2.0 SITE CHARACTERISTICS

2.1S Geography and Demography

2.1S.1 Site Location and Description

Figure 2.5S.4-7 Site-Specific Sand Shear Modulus Curves Based on RCTS Testing (FSAR Figure 2.5S.4-62)

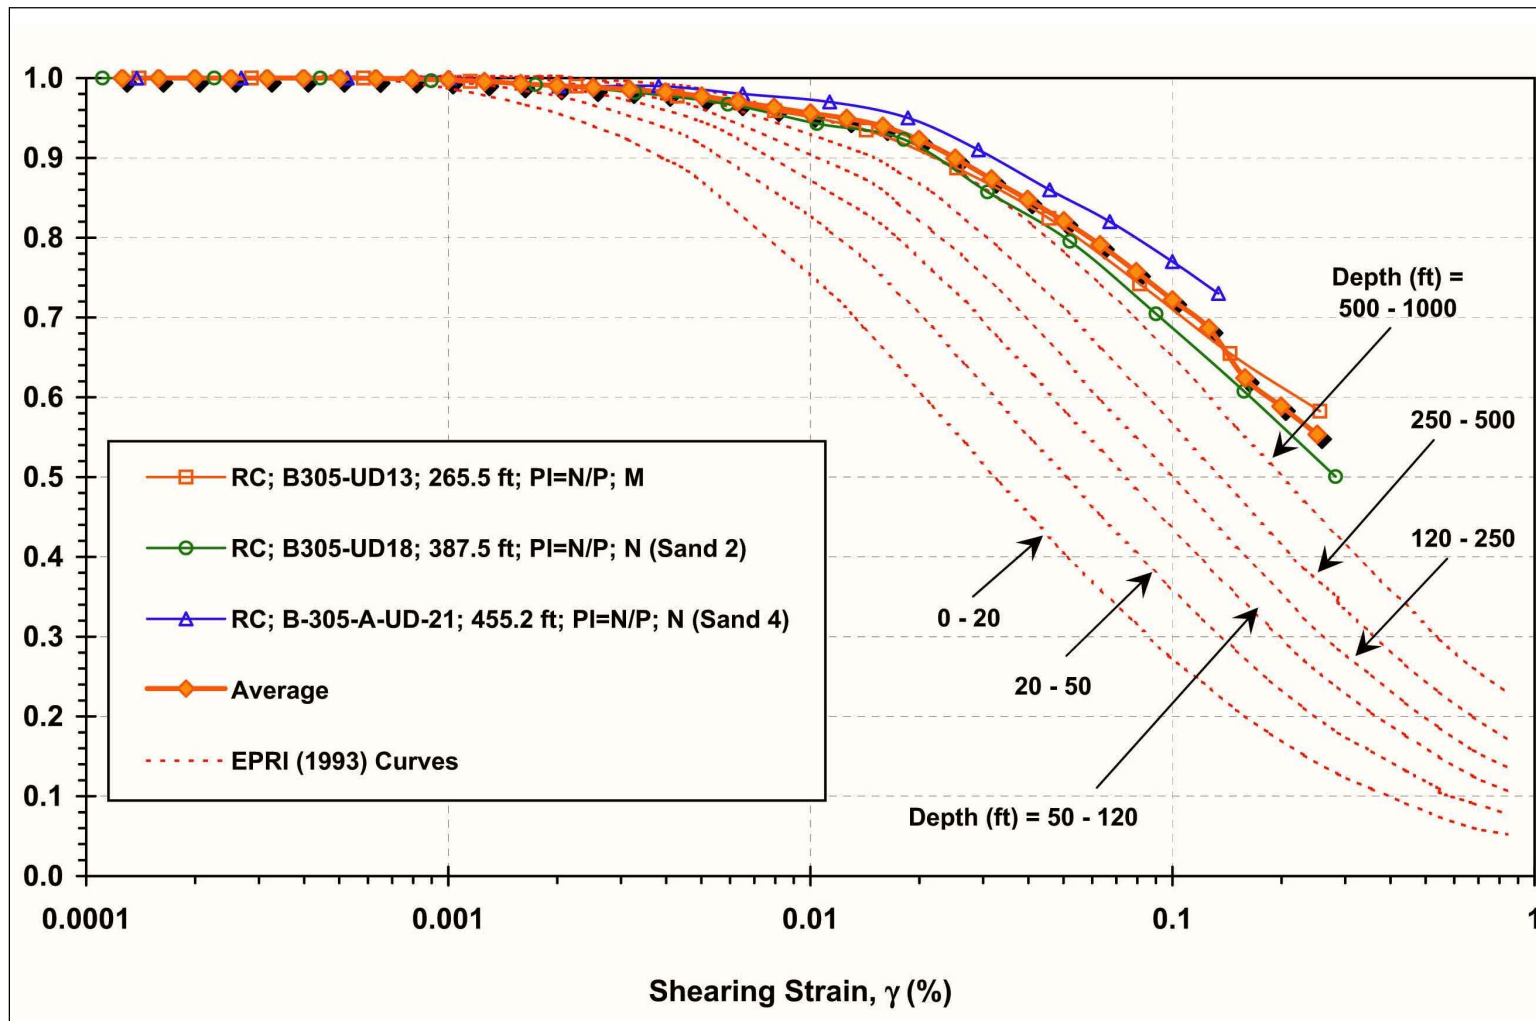
The applicant selected the generic shear modulus curves for cohesionless soil based on the stratum depths shown in SER Figure 2.5S.4-7. Similarly, the applicant selected generic shear

The staff reviewed the applicant's RCTS results and the comparisons to the literature-based curves presented in FSAR Figures 2.5S.4-62 through 2.5S.4-68. Except for the deep cohesionless soils in FSAR Figure 2.5S.4-63, "Shear Modulus Degradation Based on RCTS Testing - Deep Sand Samples," the staff agreed with the applicant that the site-specific curves are bounded by the literature-based curves and selected the literature-based curves that best define the trend of the site-specific curves for use in computing the GMRS with one exception: the deep cohesionless soils in SER Figure 2.5S.4-1 display a stiffer response than the EPRI curves. However, considering that the EPRI curve selected to represent the deep sand strata is not significantly different from the site-specific curves out to a strain of 0.1 percent, and the logarithmic mean maximum strain profiles in SER Figure 2.5S.4-11 (FSAR Figure 2.5S.2-47, "Logarithmic Mean Maximum Strain Profiles"), are typically significantly less than 0.1 percent strain, the staff concluded that the selected literature-based curves track well with the site-specific curves and are appropriate for determining the GMRS. Finally, the staff concluded that the characterization of the dynamic properties of the in situ materials is complete, therefore, RAI 02.05.02-17 is resolved and closed.
